# **DYNA-QUIK Model 650**

**DYNAMIC MUTUAL CONDUCTANCE  
TUBE & TRANSISTOR TESTER**

## **SERVICE INFORMATION**

## B&K MODEL 650 SERVICE BULLETIN

Schematic of Model 650 Test Panel

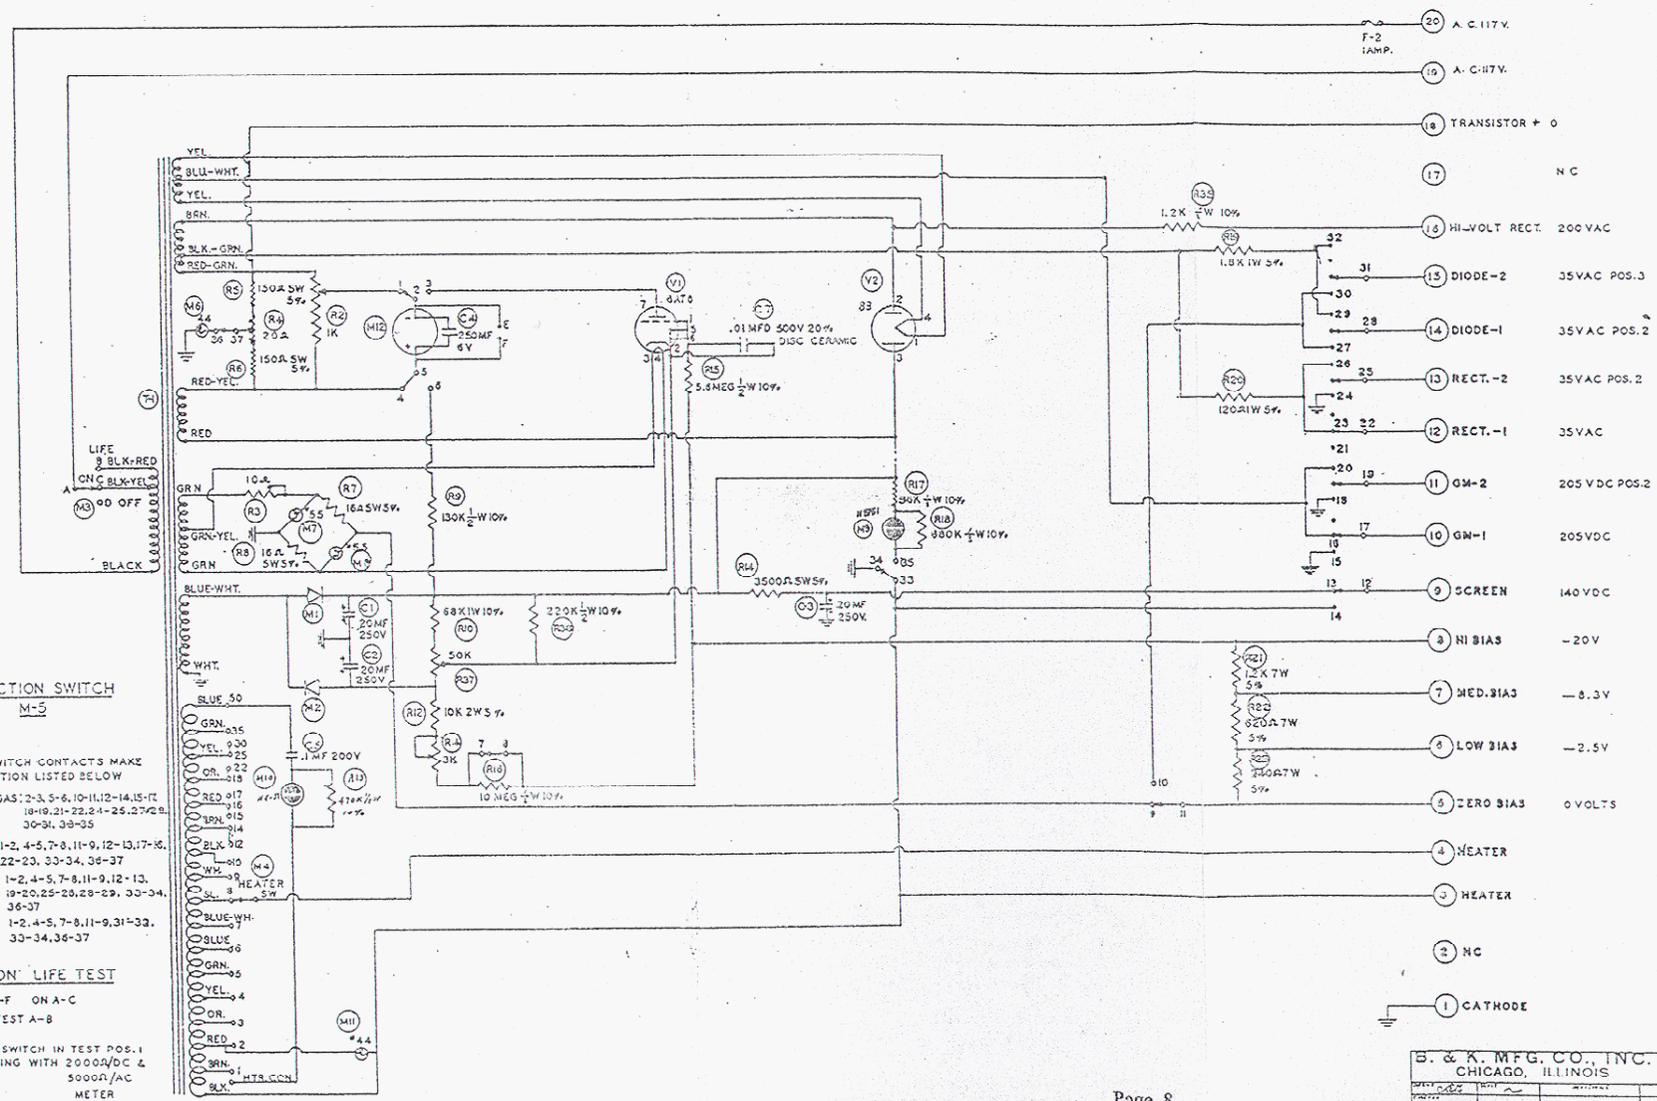
Changing the # **49** pilot lite to a # **44** bulb has been done in production at serial # **5163** .

The reason for the change is to prevent a possible burn out of the # **49** pilot lite used as a fuse.

Add **R-35** resistor this has been done in production at approximately serial # **4700** and up. Check to see if this change has bin made.

**R-35** is a **1200** ohm **1/2** watt **10%** carbon resistor in series with high voltage terminal #**16** on main panel.

Change **R-20** resistor this has been done in production at approximately serial # **4700** and above. Old **R-20** is a **82** ohm **1** watt resistor.

The new **R-20** must be a **120** ohm **1** watt **5%** resistor .

Change **R-18** resistor this has been done in production at approximately serial # **5000** and above. Old **R-18** is a **270K** ohm **1** watt resistor.

The new **R-18** must be a **470K** ohm **1** watt **5%** resistor.

This change increases the sensitivity of the shorts check.

Change **R-10** and **R-11** resistor this has been done in production at approximately serial # **6000** and above. Old **R-10** is a **100K** **1** watt resistor the new **R-10** must be a **120K** ohm **1** watt **5%** resistor . Old **R-11** is a **22K** ohm **1/2** watt resistor, The new **R-11** must be a **27K** ohm **1/2** watt **5%** resistor. This increases stability of the grid emission check.

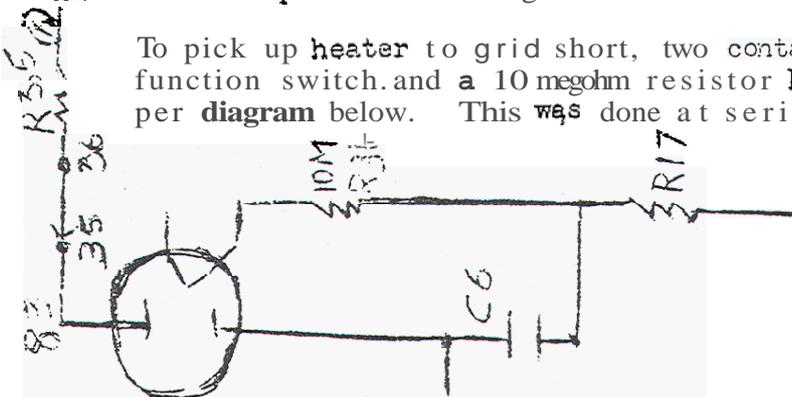
To pick up heater to grid short, two contacts were added to the function switch and a 10 megohm resistor R-36 is added to circuit per diagram below. This was done at serial #5575.
